**BUILDINGS 5 & 6 RENOVATIONS**

**CAÑADA COLLEGE**  
4200 Farm Hill Boulevard  
Redwood City, CA 94061

**THIRD FLOOR EXITING PLANS**

| REVISIONS      | DATE     |
|----------------|----------|
| REF - 76       | 06/10/11 |

**THIRD FLOOR DEMOLITION PLAN**

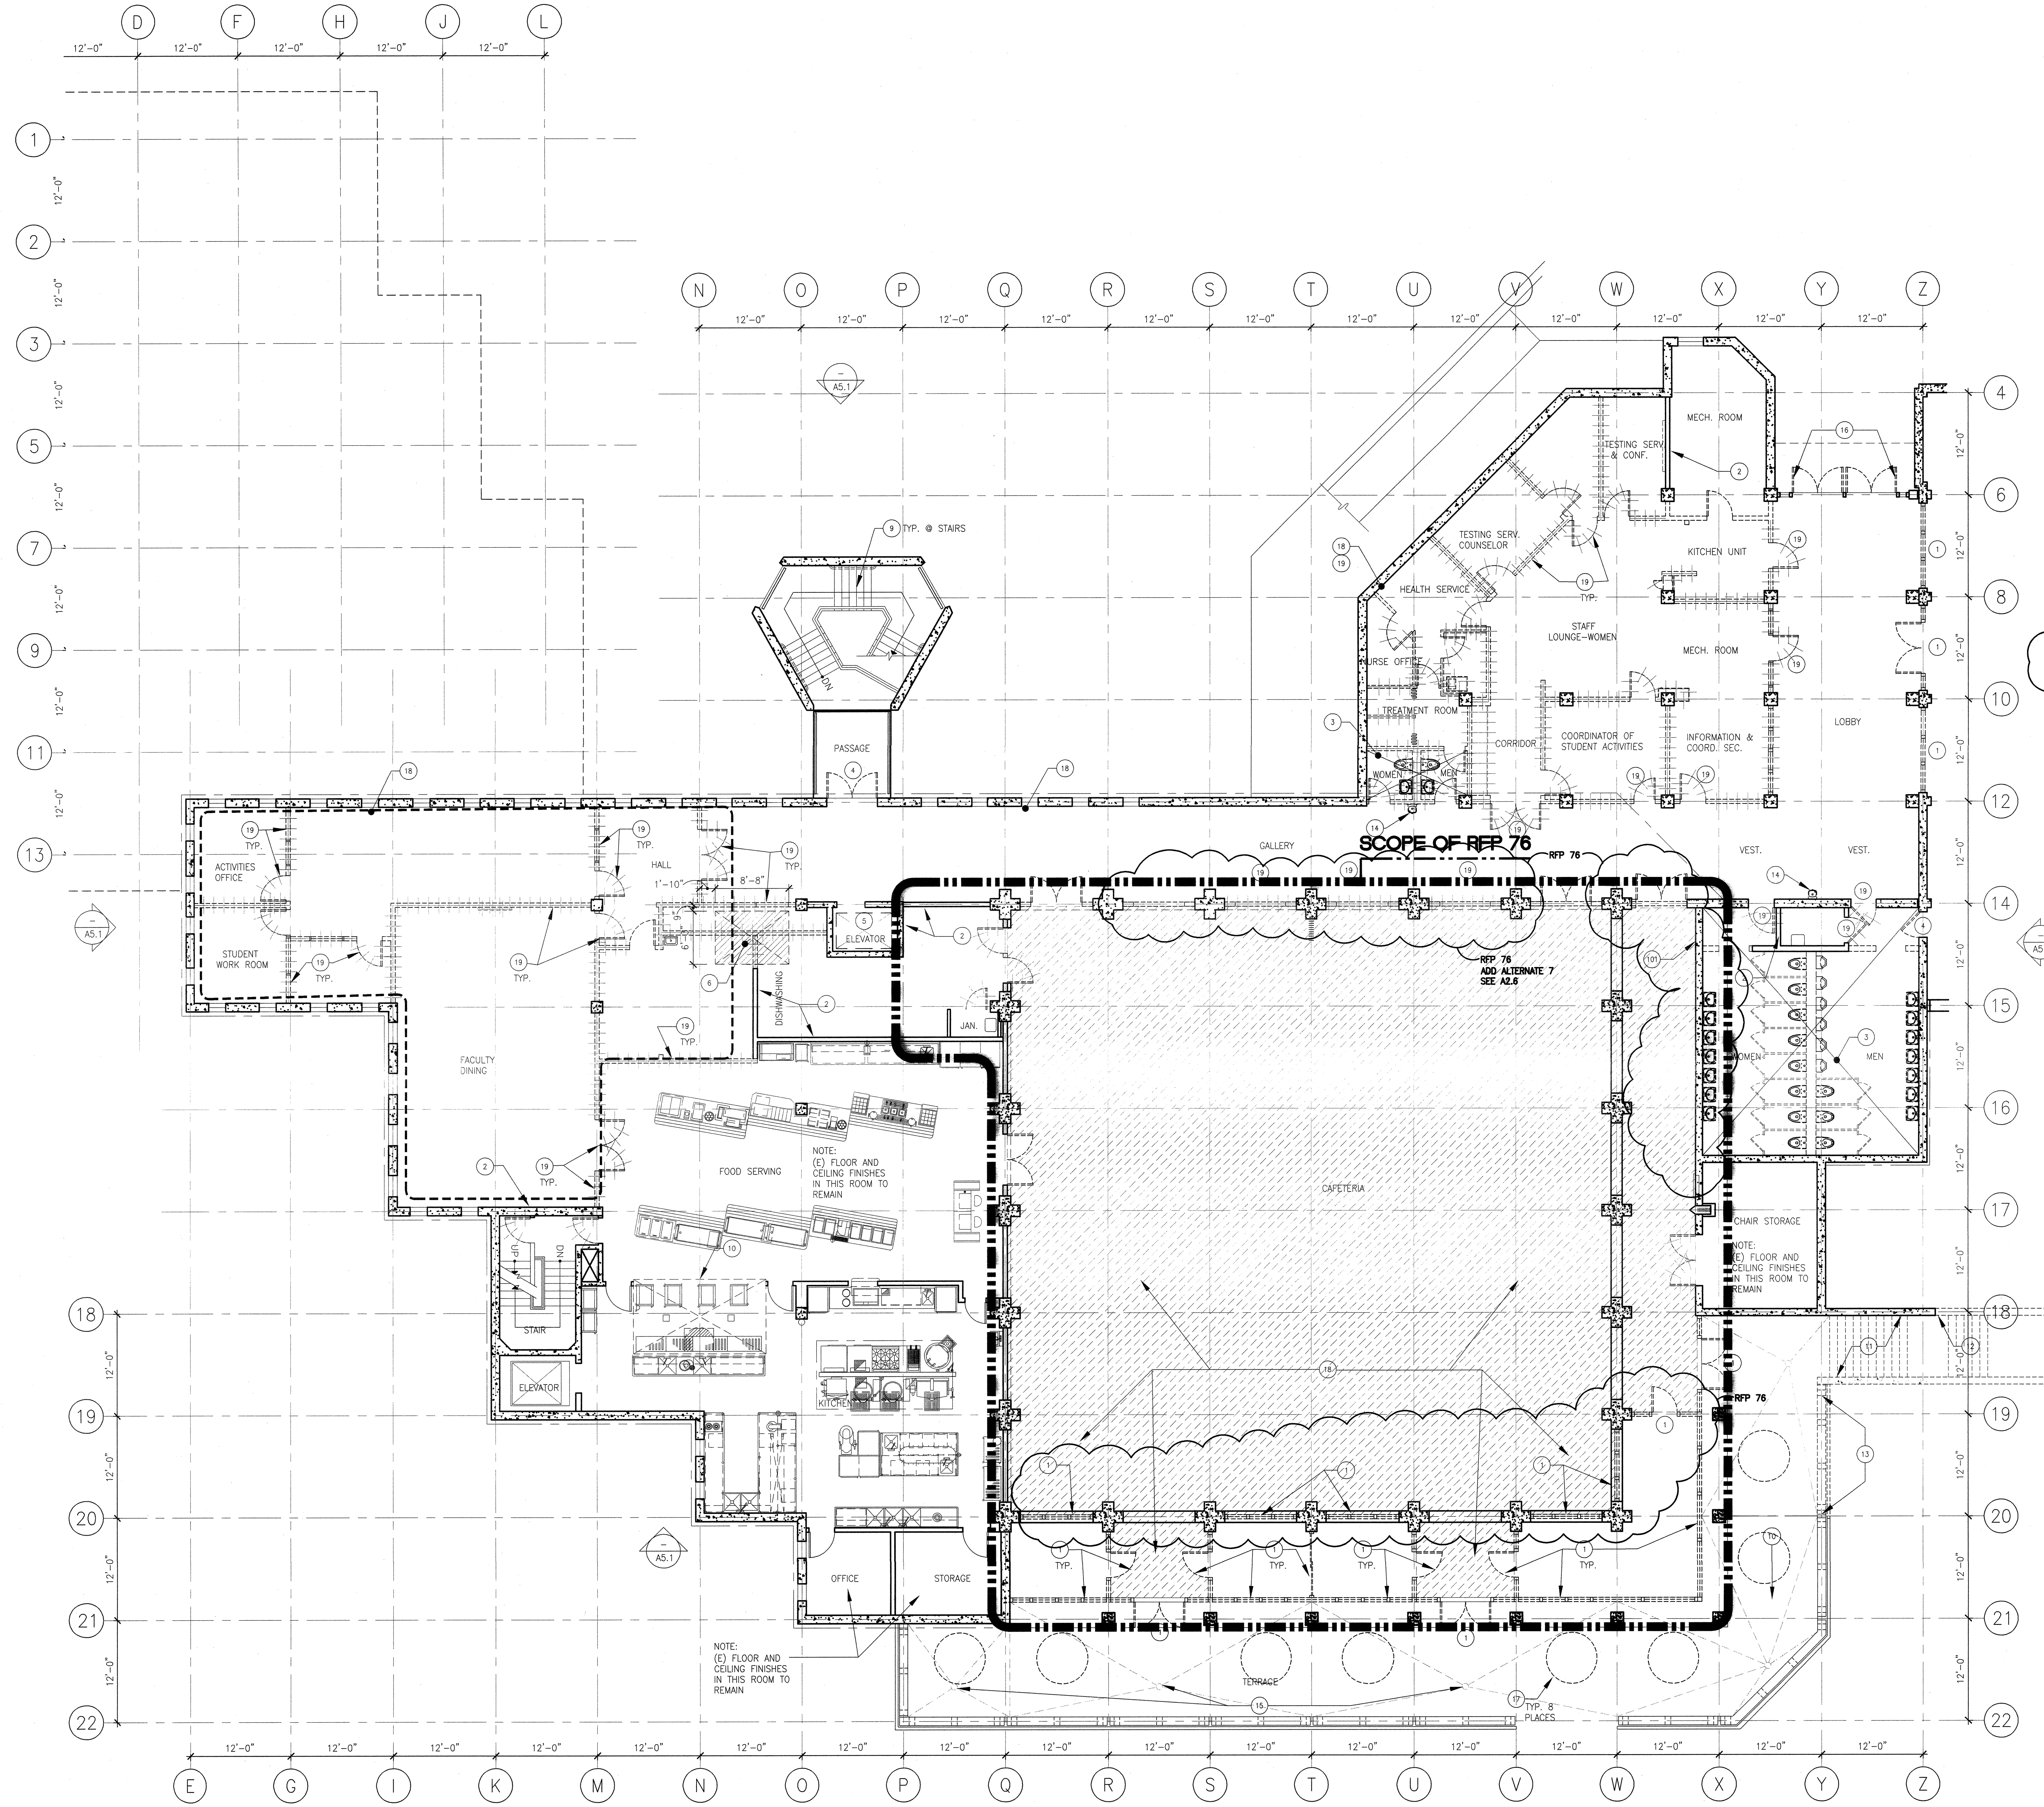
REF 76  
REMOVE (E) DOOR AND FRAME AND RELOCATE TO (N) LOCATION.

- I. ADDITIONAL DEMOLITION SCOPE UNDER REF 76 PERTAINS ONLY TO INTERIOR RENOVATIONS OF CAFETERIA. SCOPE OF THIS WORK DOES NOT INCLUDE ANY DEMO OF EXTERIOR STOREFRONT SYSTEM. SEE REF 76 REVISION CLOUD FOR EXTENT OF DEMO.
